ADDENDUM 2 – JOB 23244

TO: All prospective bidders on Projects TAU-4-989(126) and TAU-4-989(127), Job No. 23244 scheduled for the March 3, 2023 bid opening.

PLAN ADDENDUM SUMMARY AND APPROVAL

PROJECT INFORMATION		
Project: TAU-4-989(126) & TAU-4-989(127)		PCN: 23244 & 23245
Location: 25 th St NW, 10 th Ave NW, and 27 th St NW & Hiawatha St SE - Minot, ND		
Date: 2/24/2023	Lead Designer: Jesse Hoffart, PE	
Bid Opening Date: 3/3/2023	JOB#: 23244 & 23245	Addendum#: 2

NOTES				STATE	PROJECT NO.	PCN NO.	SECTION NO.	SHEET NO.																
251-P01 SEEDING CLASS III: Use the following seed mix for all permanent seeding:				ND	TAU-4-989(126)	23244	6	2

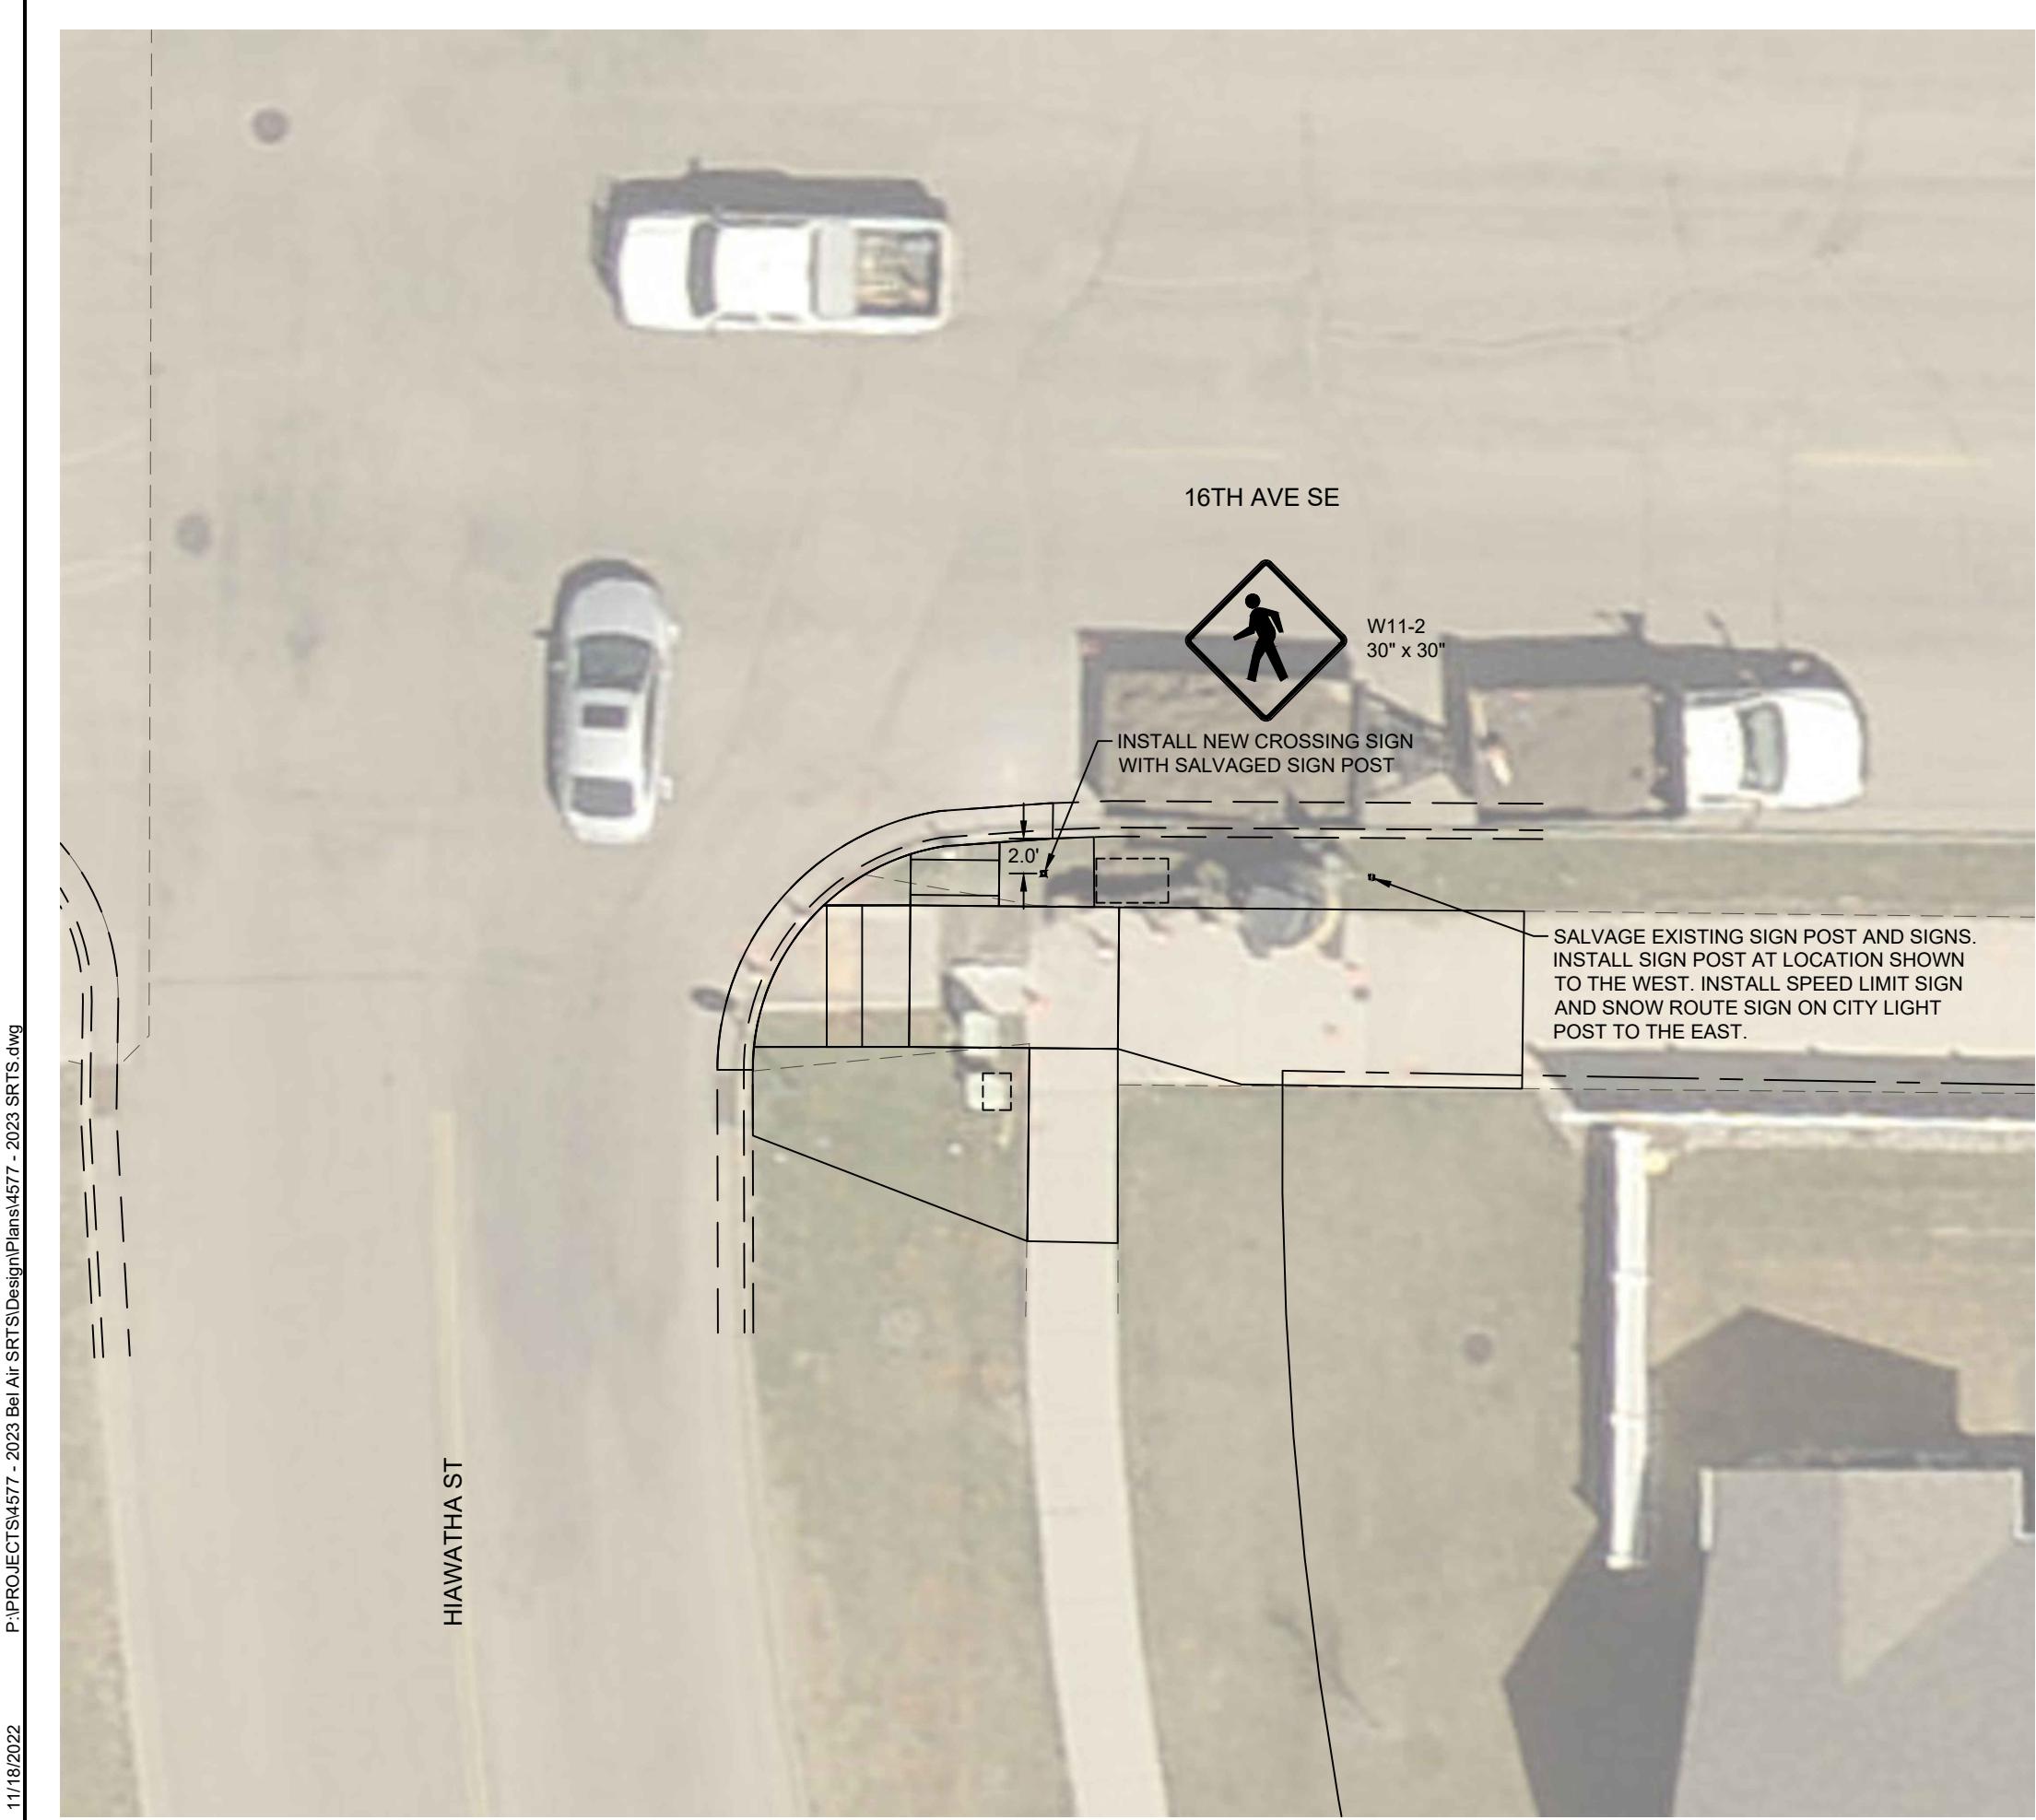
PLAN SHEET CHANGES		
Section	Sheet	Description
6	2	Removed Note 704-P04, as there are no PCMS's specified for this project.
8	1	Updated quantities for item 754-110.
110	2	Sheet quantity table needs to be updated. First item has wrong quantity. Second item is not needed. Also specified sign size.
